Tuesday, June 6, 2023  
Addendum #1

**UNIVERSITY OF NORTH CAROLINA CHAPEL HILL  
UNIVERSITY ART STUDIO – FIRE PROTECTION  
GROUP 4: MULTIPLE CHILLER REPLACEMENTS**

UNCCH POID # Y23JME0010 | SCO ID # 22-24805-01A | Sigma Project # 22031

F100

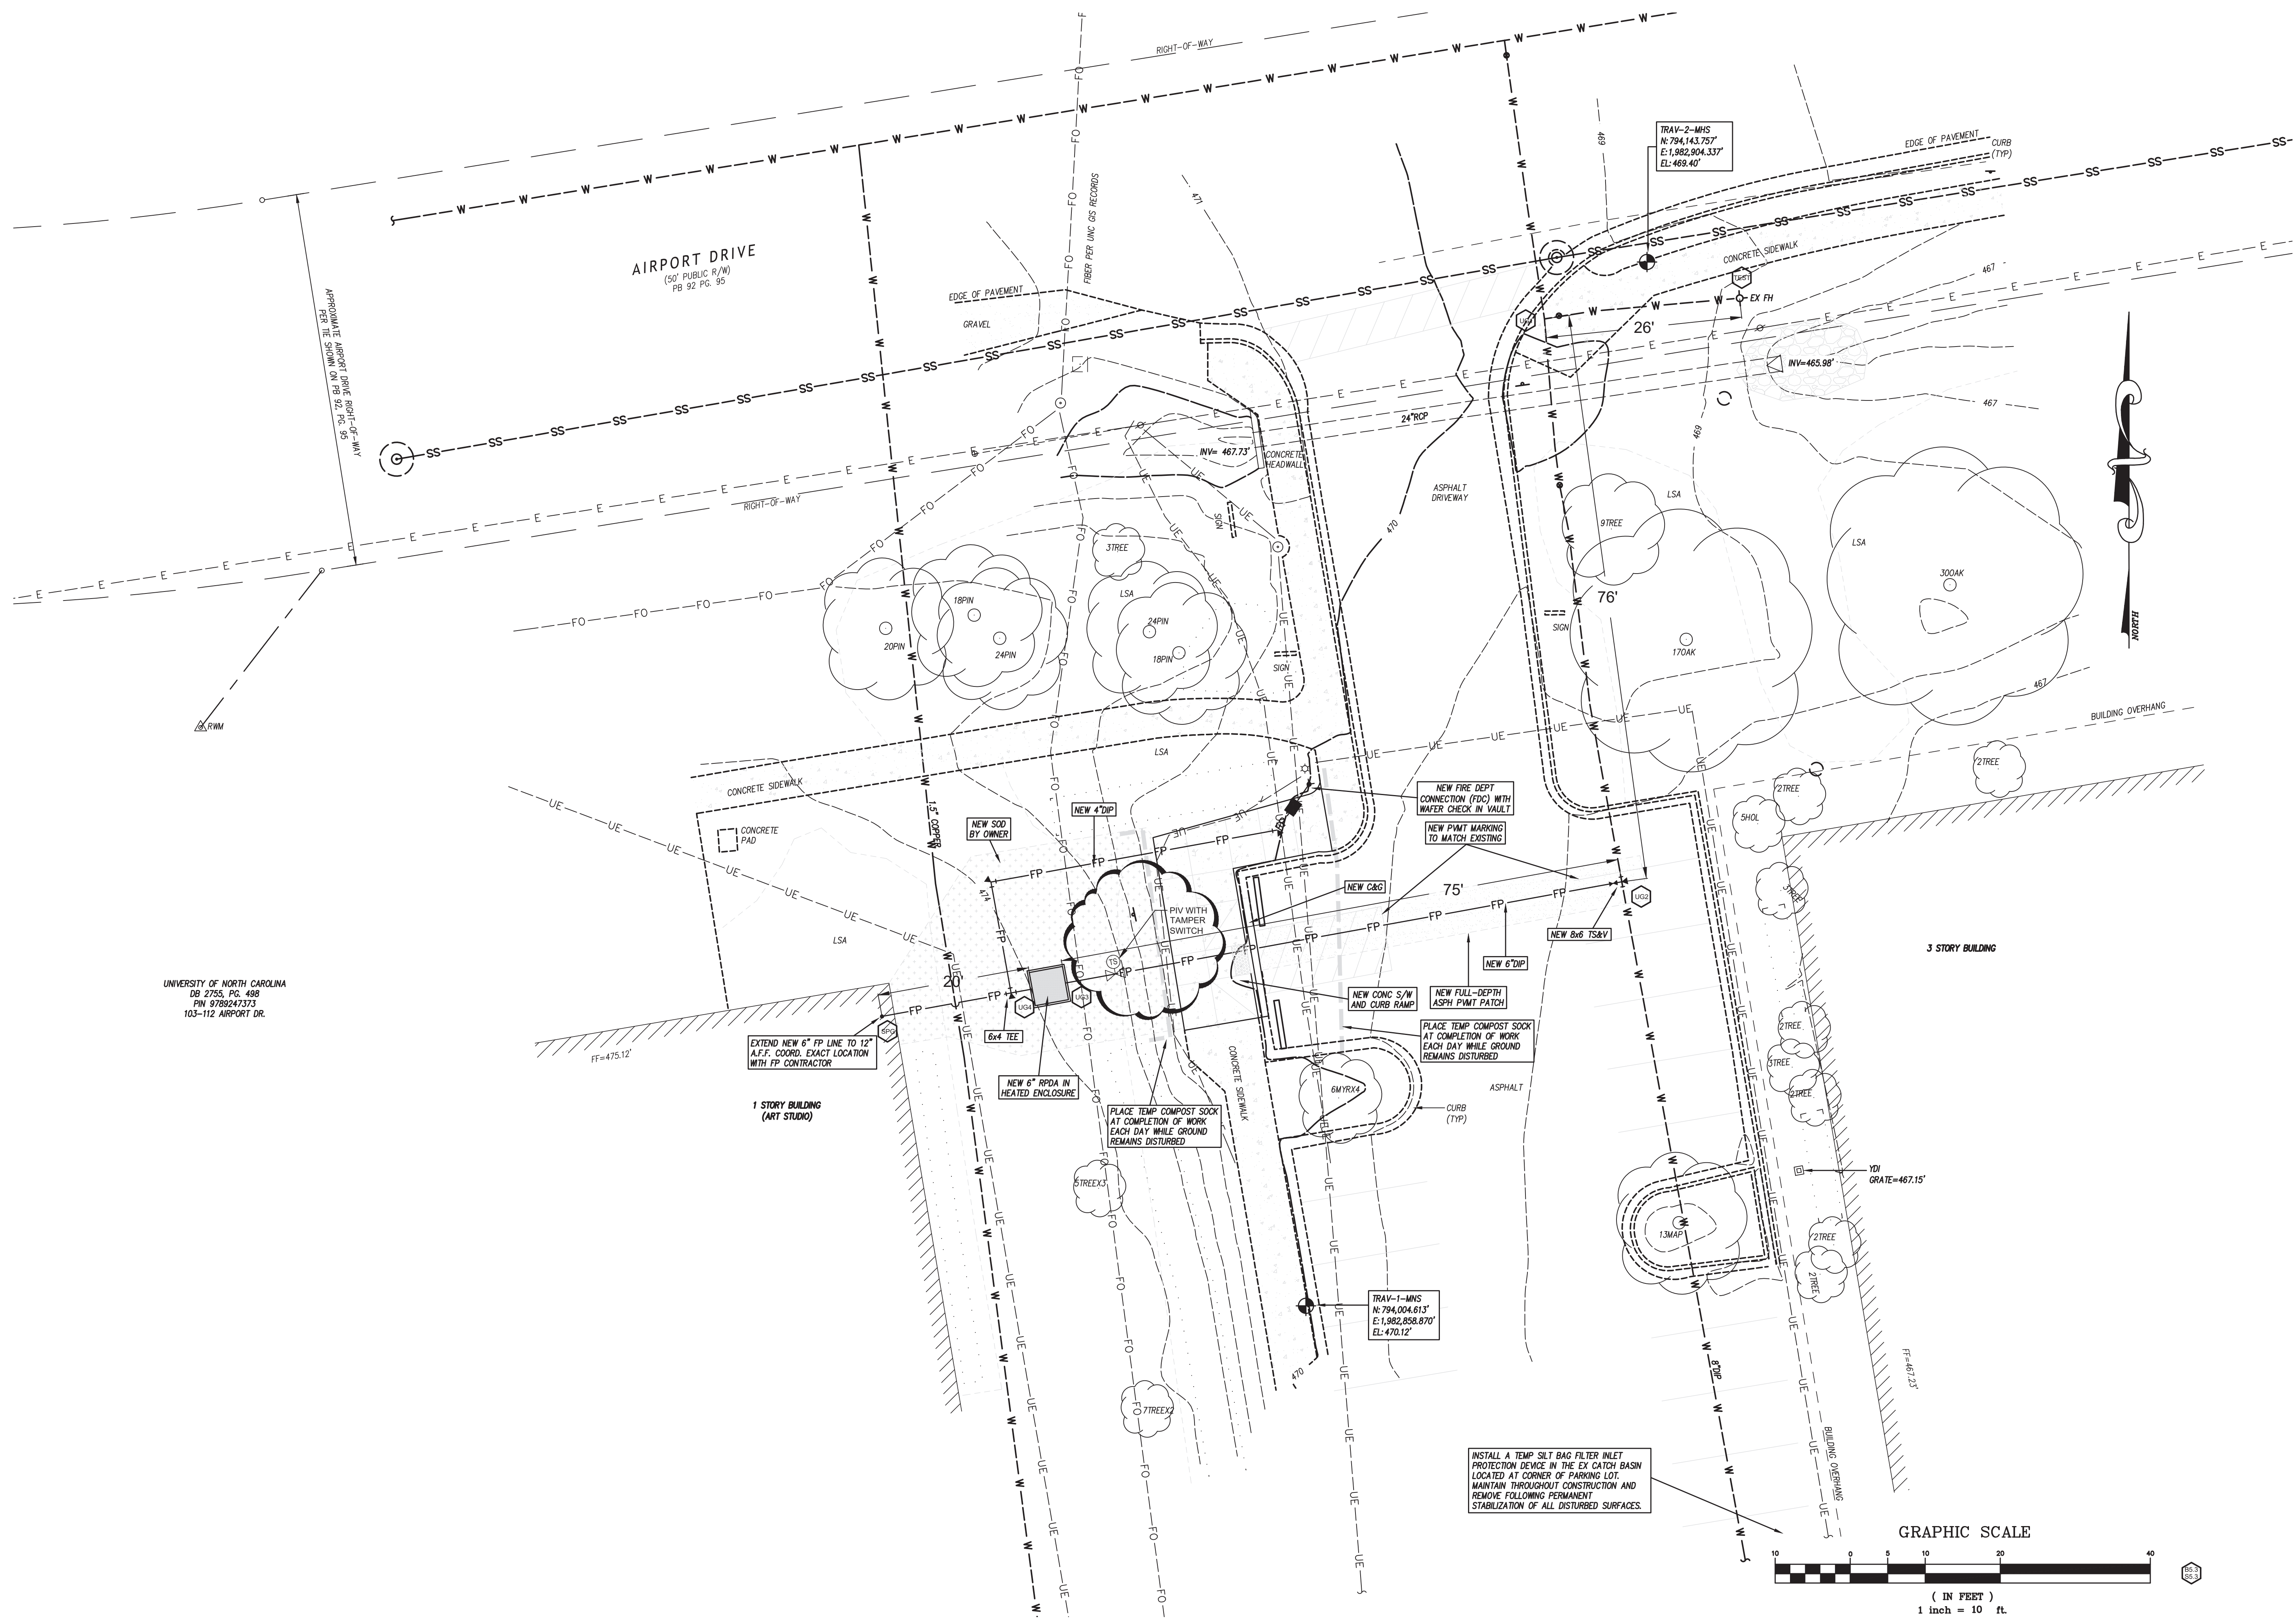
- a) Sheet F100 – Revised to include PIV.
- b) Sheet E200 – Revised to include PIV fire alarm connection.
- c) Sheet E401 - Revised to include PIV on riser diagram and fire alarm matrix.

- c) **Q:** There is also no PIV with tamper switch shown on the electrical or sprinkler drawings

**A: Refer to sheets listed under ITEM 4 – CHANGES TO DRAWINGS.**

**E200**

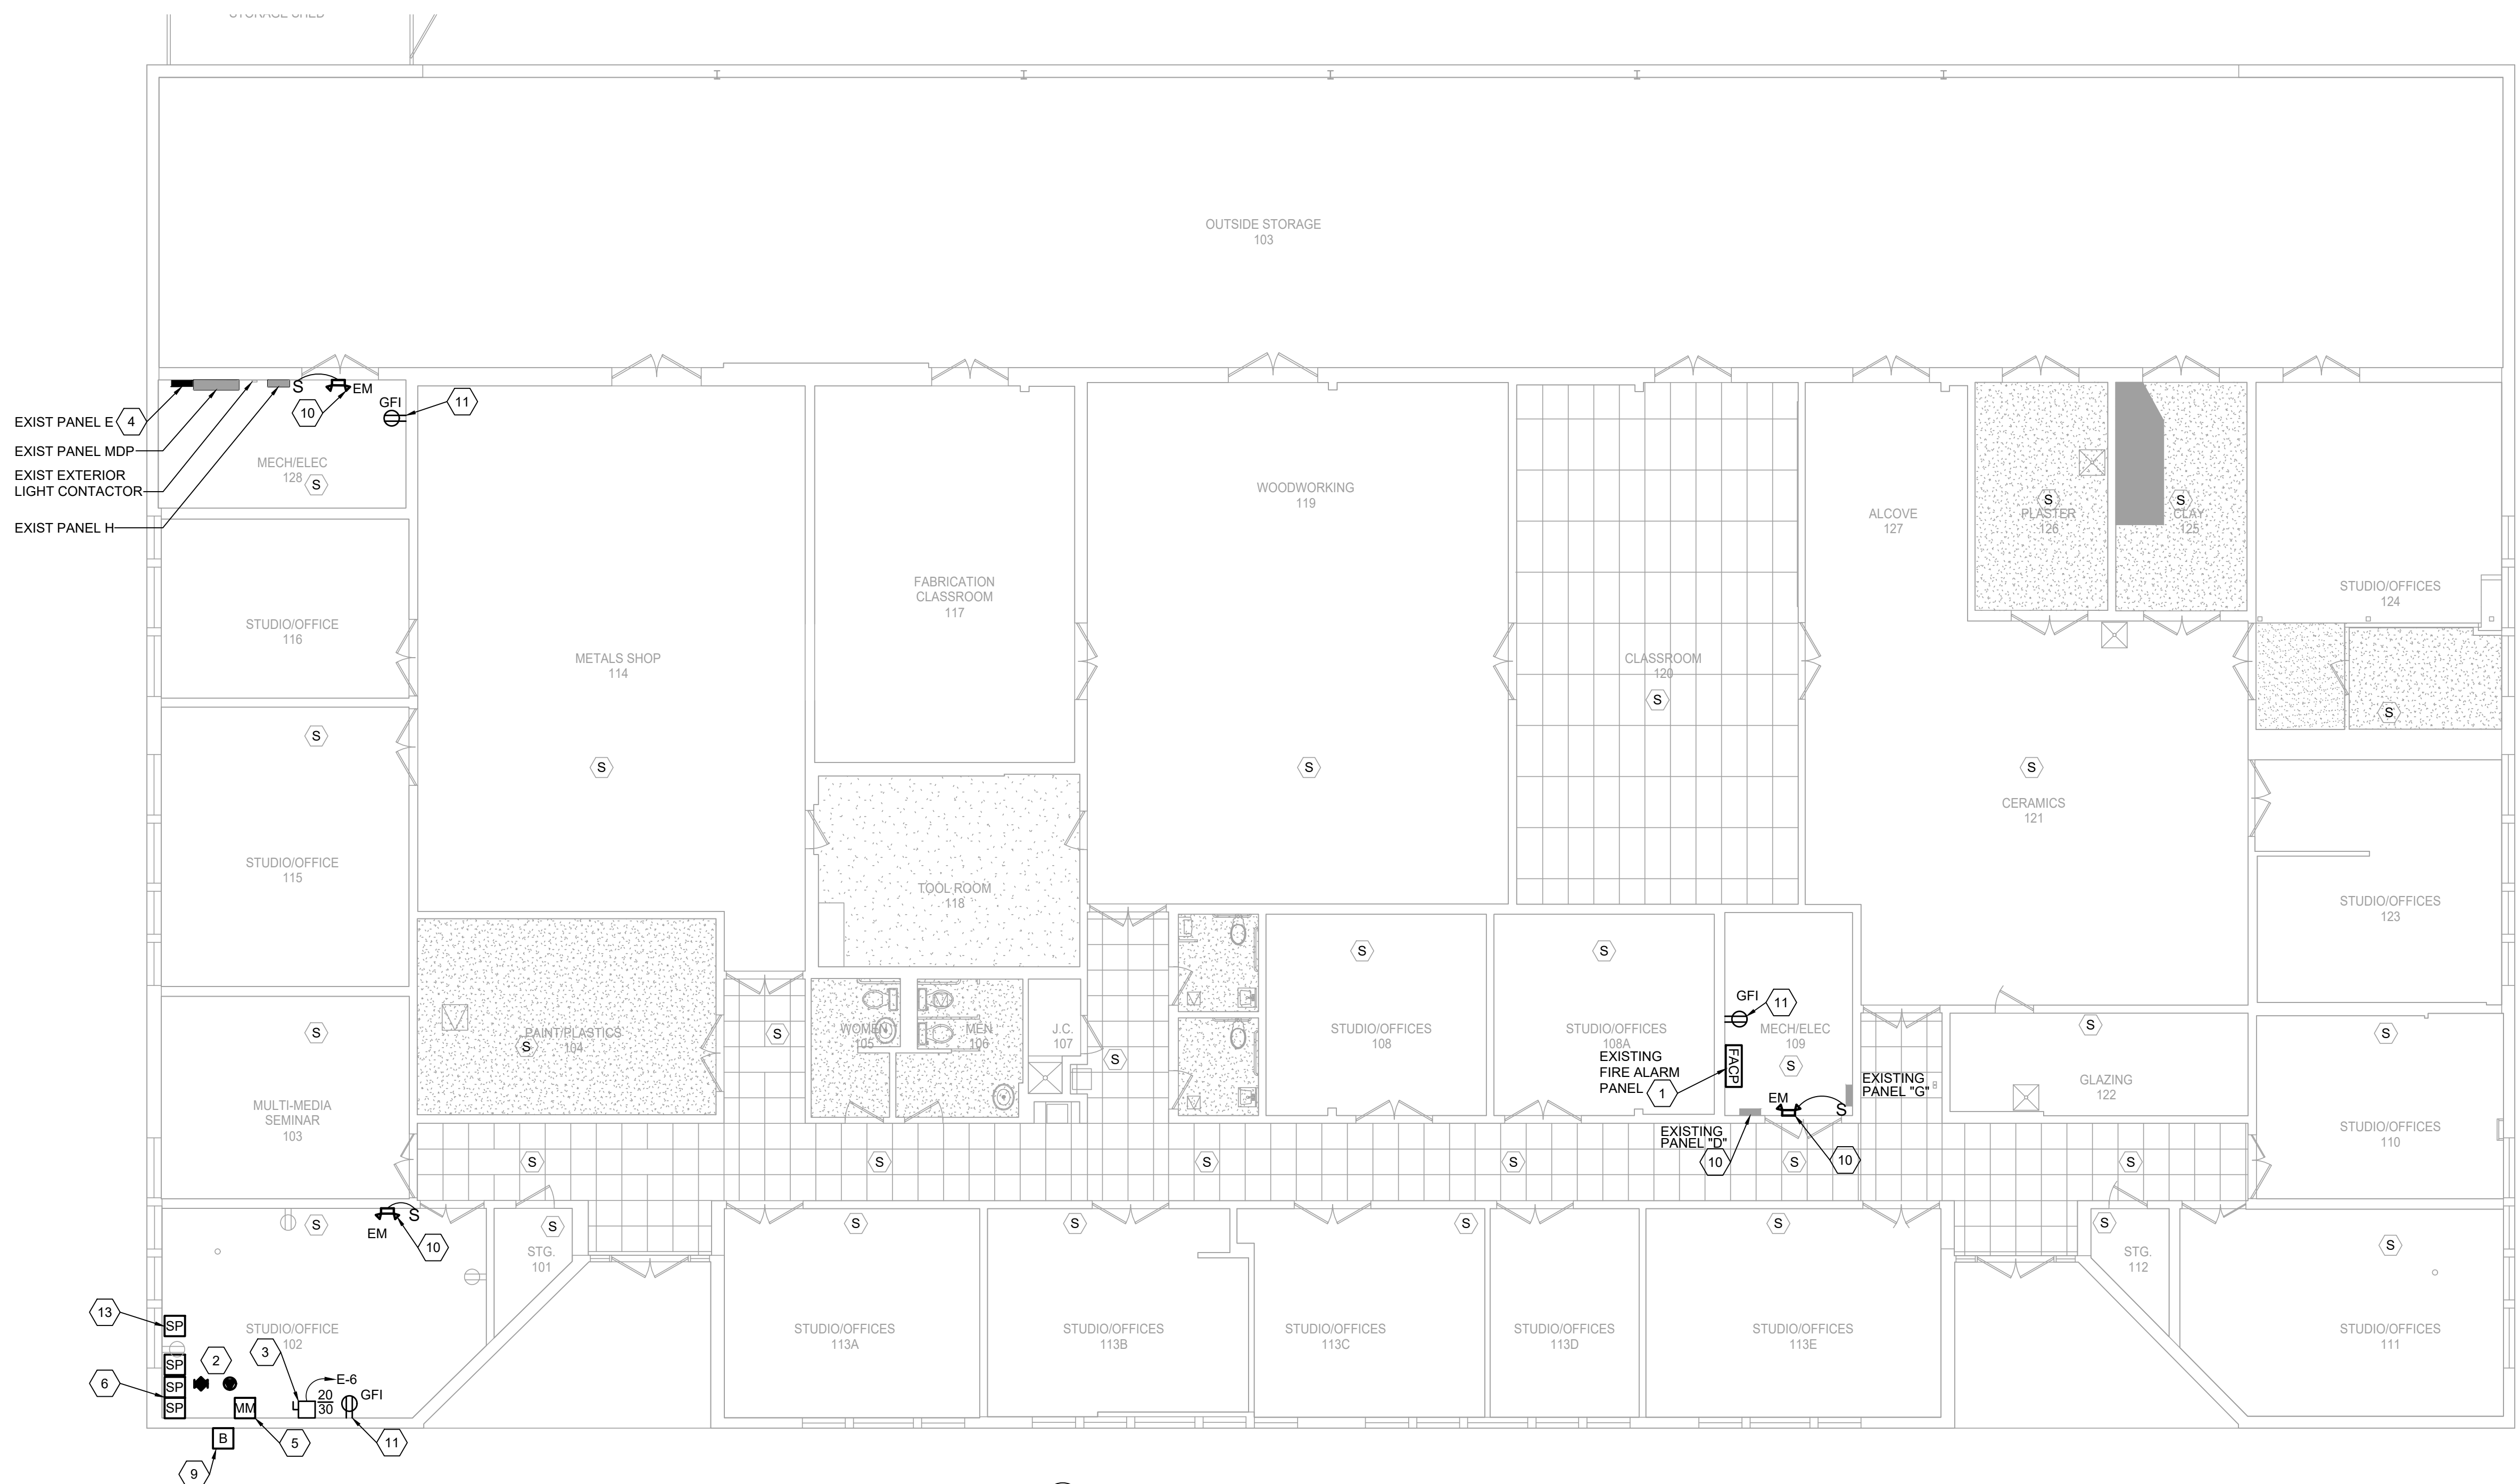
- 12 PROVIDE A RED BREAKER LOCK ON DEVICE ON FIRE ALARM PANEL CIRCUIT 27.
  - 13 TAMPER SWITCH AND SURGE PROTECTION DEVICES FOR PIV. REFER TO DRAWING C2.1 FOR LOCATION OF PIV.

1 FIRE ALARM RISER DIAGRAM  
NO SCALE:

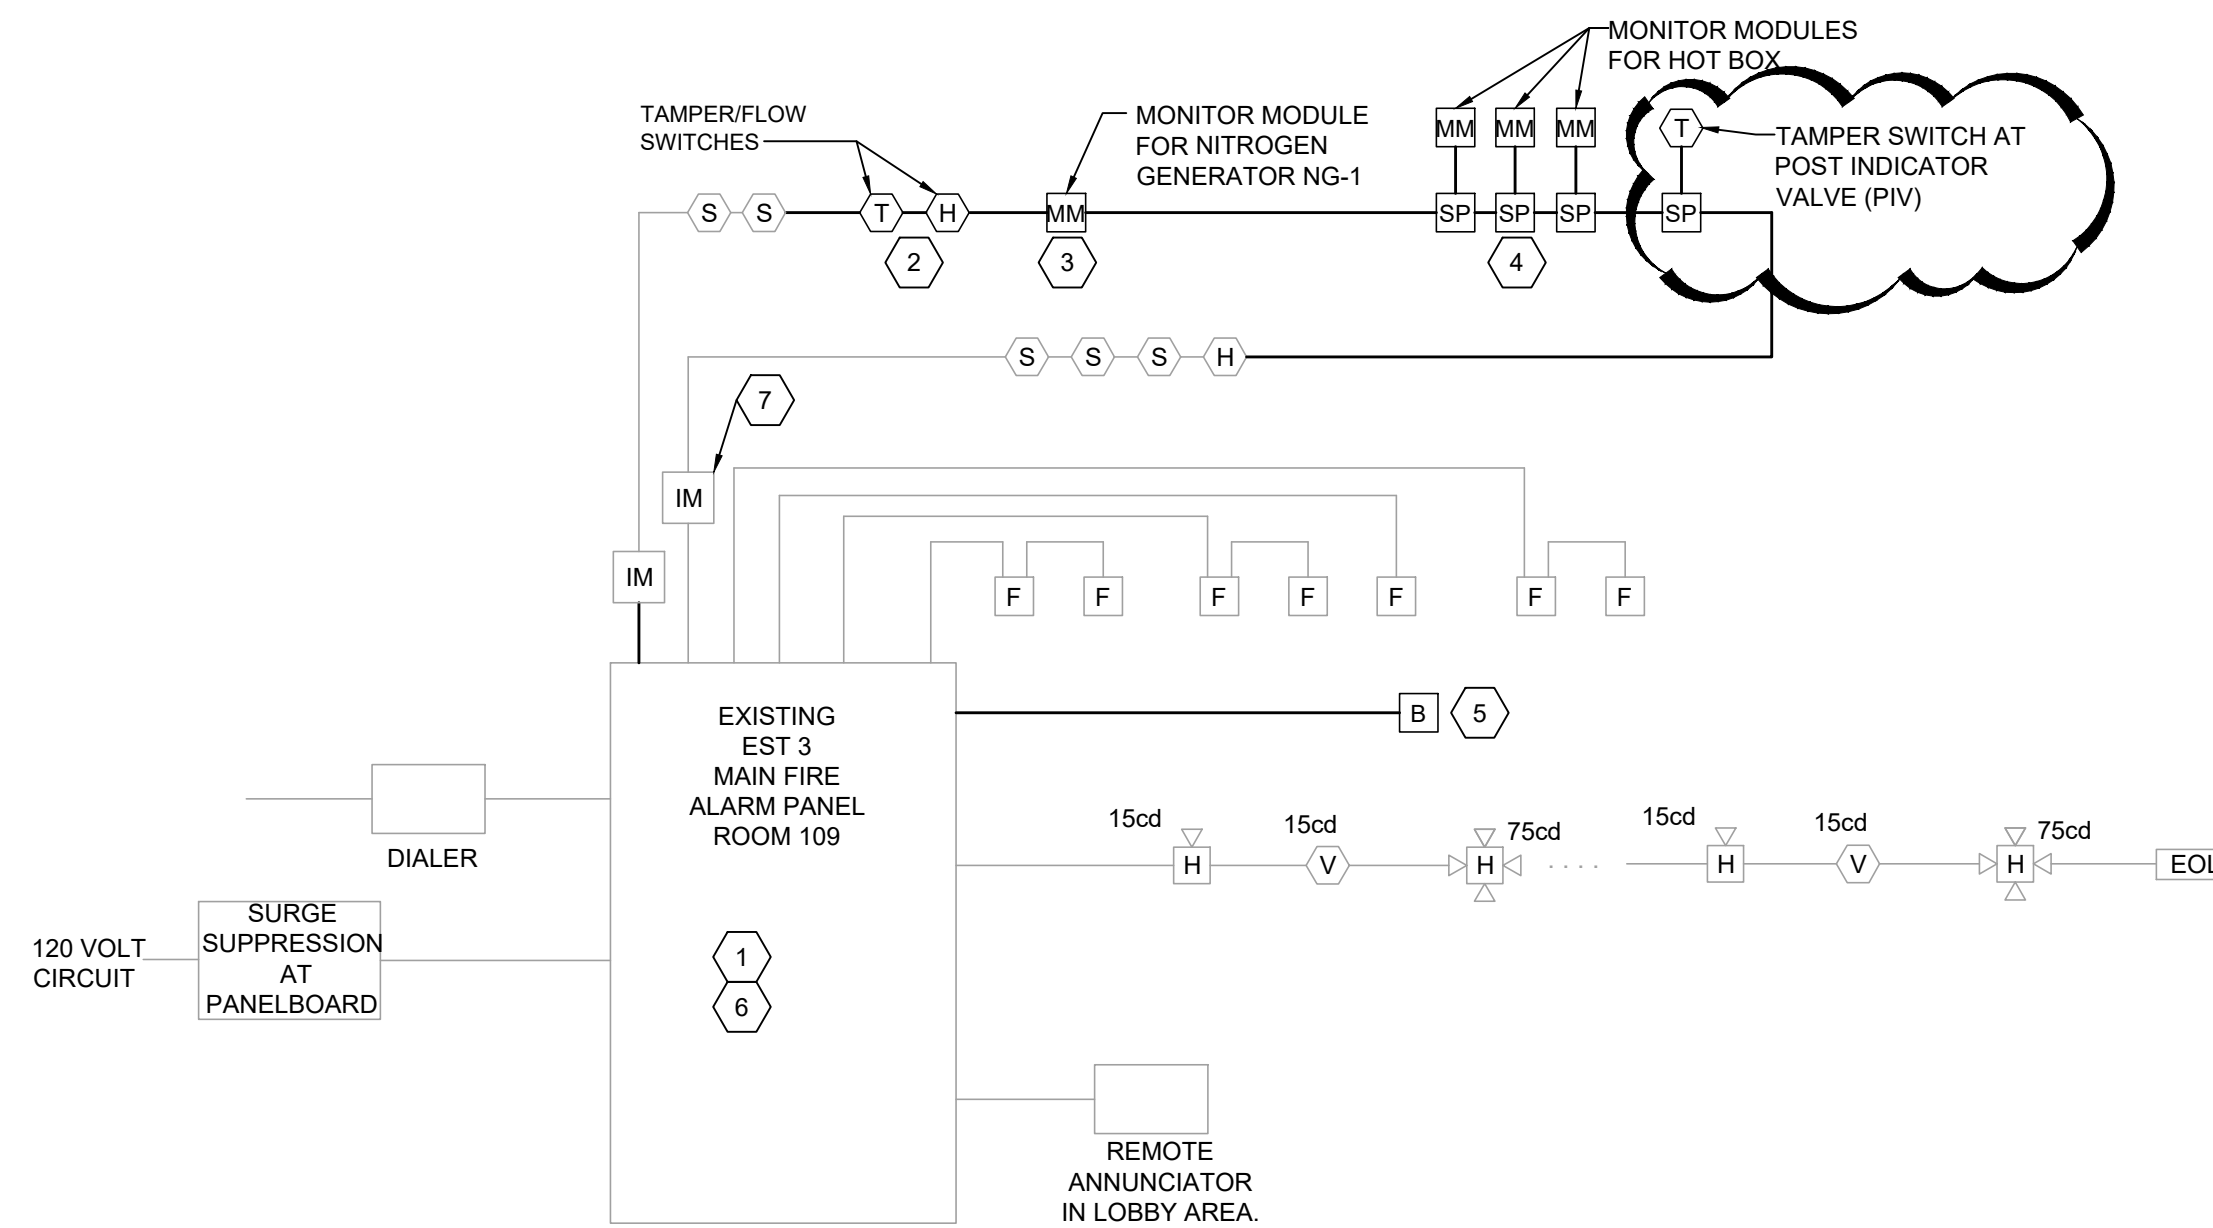
SYSTEM INPUTS	Control Unit Annunciation					Notification					Dialer							
	Common Alarm Indicator	Audible Alarm Signal	Common Supervisory Signal	Audible Common Sup. Signal	Common Trouble Signal	Floor Alarm Indicators	Activate Floor Evacuation Signal	Transmit Alarm Signal	Transmit Supervisory Signal	Transmit Trouble Signal	Activate Sprinkler Bell	Transmit Alarm Signal	Transmit Supervisory Signal	Transmit Trouble Signal	Transmit Water Flow	Close Magnetic Doors	Send Signal to BAS Control Panels (each HVAC Room)	AHU Shutdown
Manual Pull Stations	x	x				x	x	x			x					x	x	x
Smoke Detectors-Floor	x	x				x	x	x			x					x	x	x
Heat Detectors-Floor	x	x				x	x	x			x					x	x	x
Duct detectors	x	x				x	x	x			x					x	x	x
Heat Detectors	x	x				x	x	x			x					x	x	x
Tamper Switch- PIV			x	x					x									
Low Temperature-Hot Box			x	x					x									
Tamper Switch-Hot Box			x	x					x									
Tamper Switch			x	x					x
